OVERALL MASTER PLANVIEW

**MONUMENT ACADEMY
 OVERALL MASTER PLAN**

Project No./Code
 19734
 STA 105A-014
 Sheet Number 4 of 82

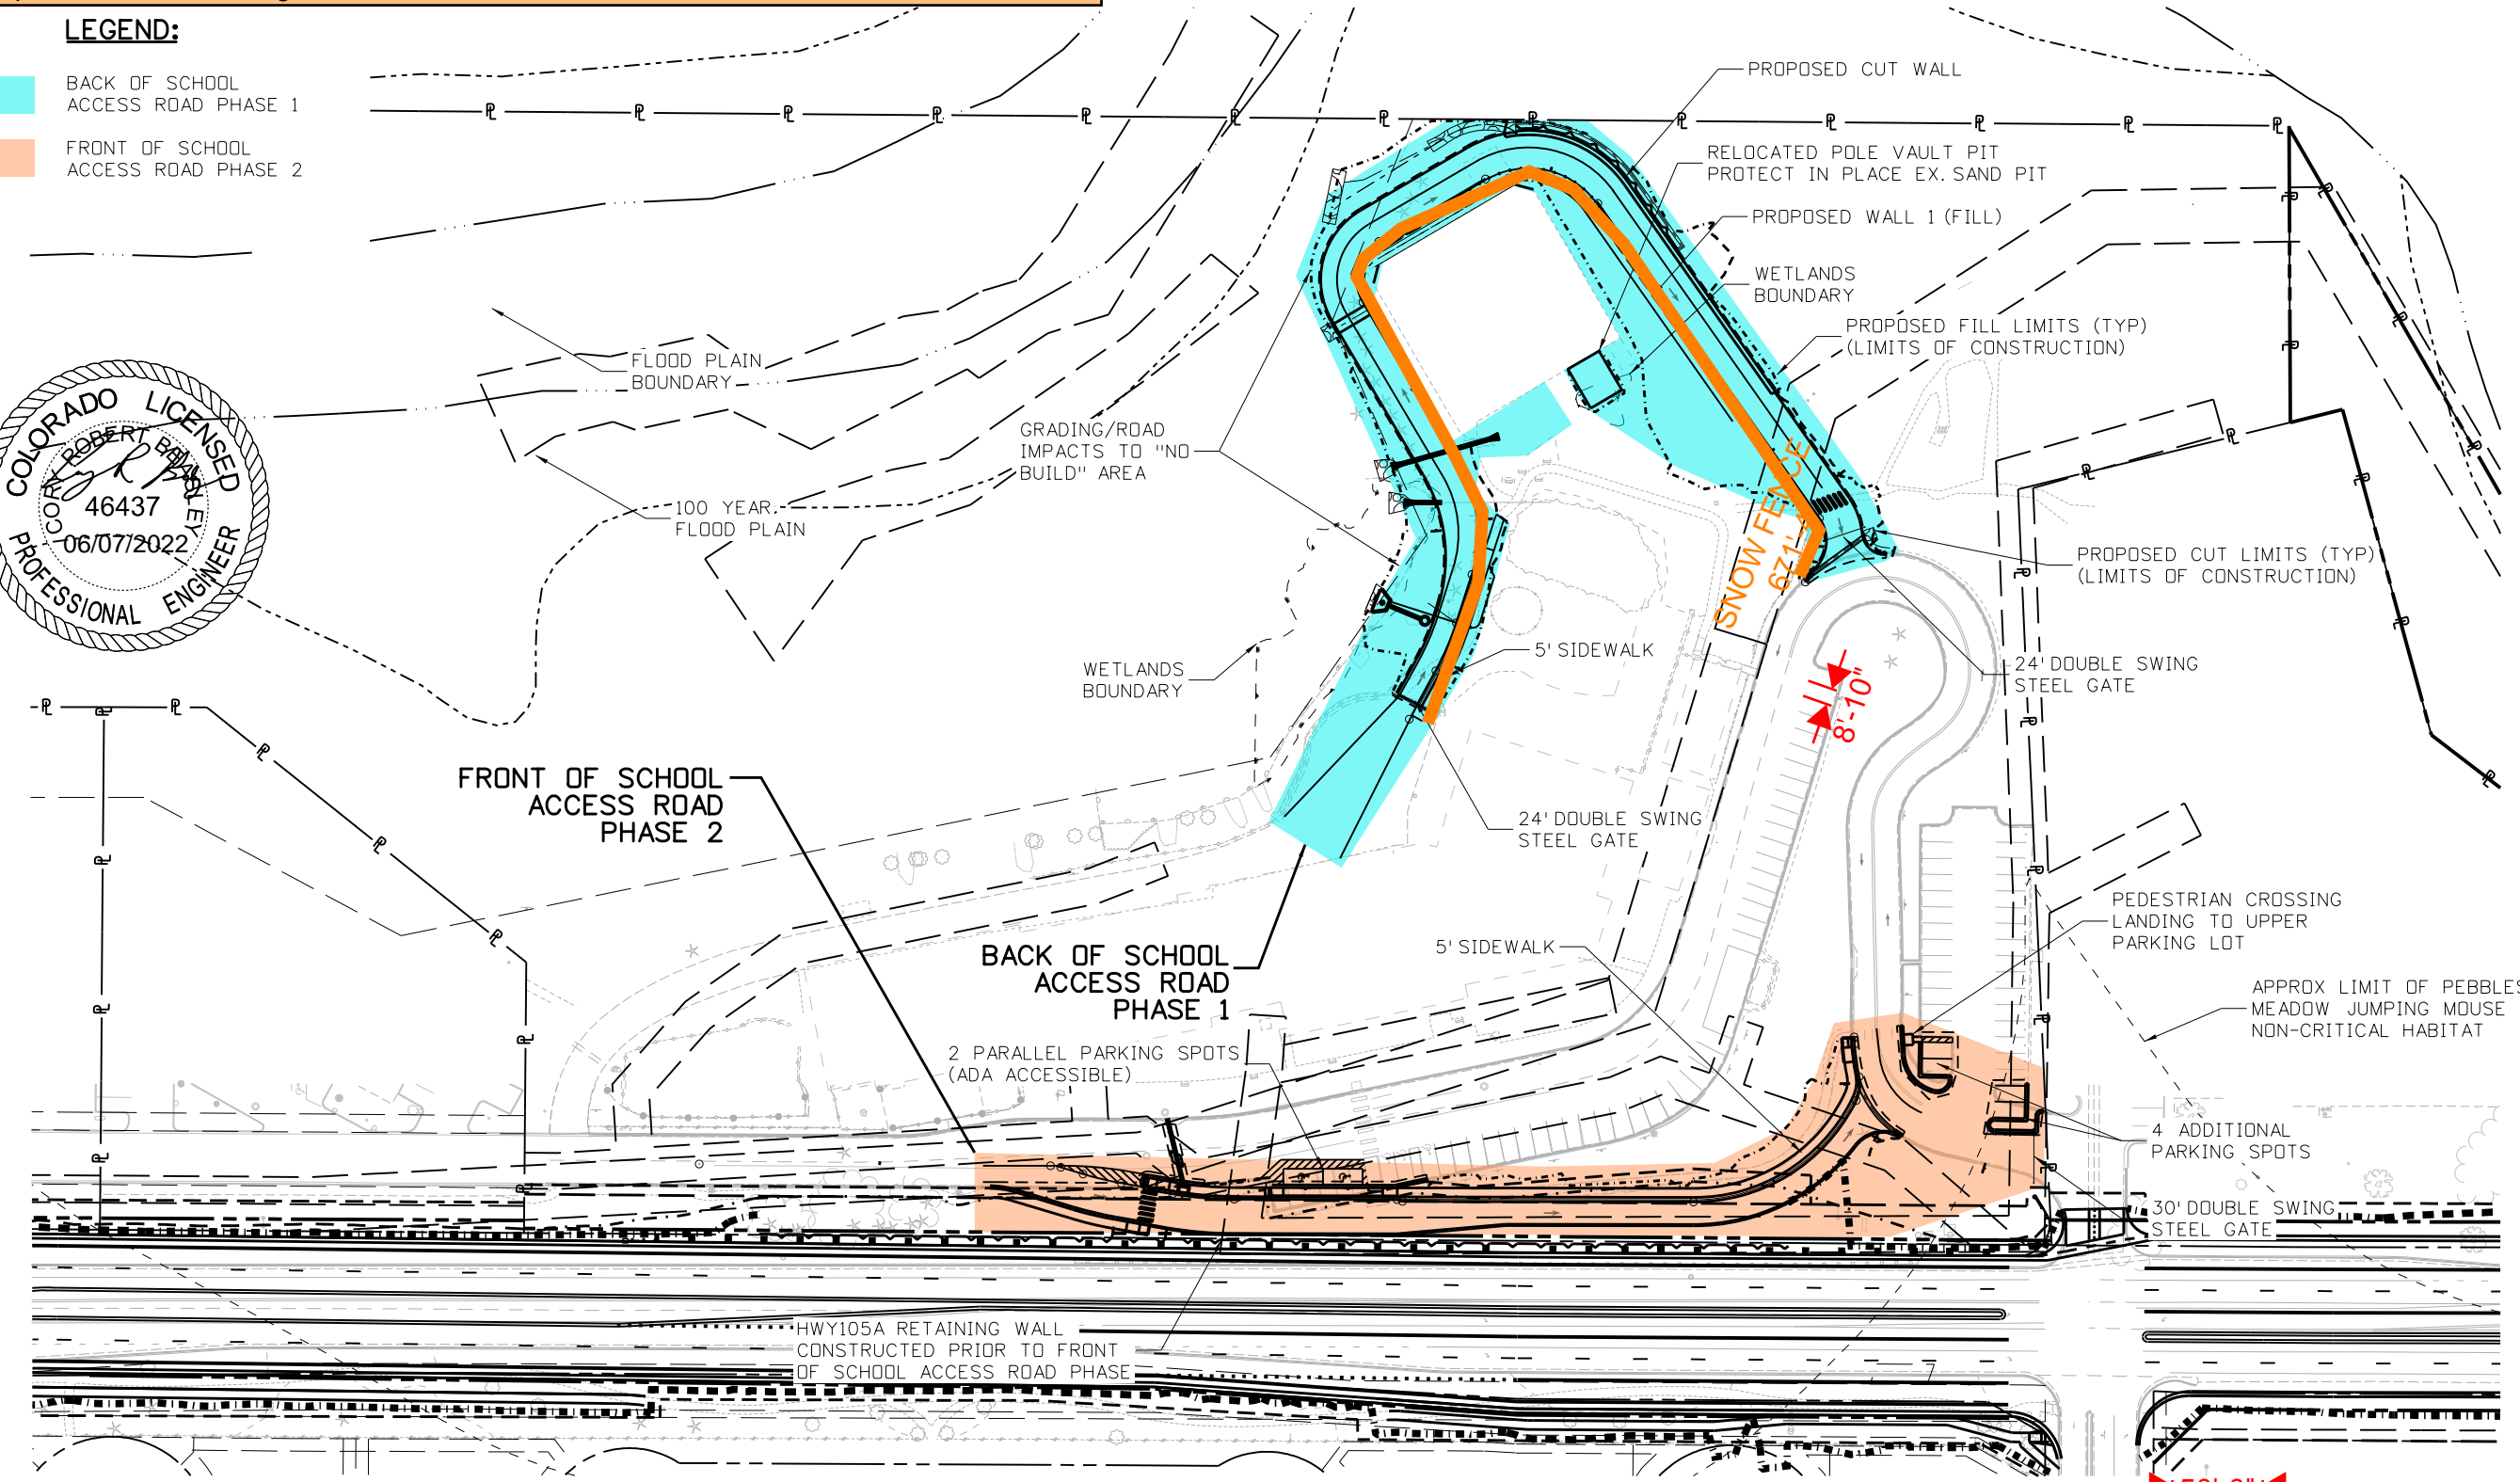
This was the only sheet uploaded to EDARP under "Drainage Plans." Please send me the full set via email so we can eventually upload it to EDARP with all of the Final docs. Otherwise our inspectors will not have details for the riprap aprons, among other things (per my Review 1 comment in the GEC Plan). On 6/1 I was emailed a 11 page excerpt but it was incomplete and marked-up with internal markings/notations. So I'd still like to see the final full set.
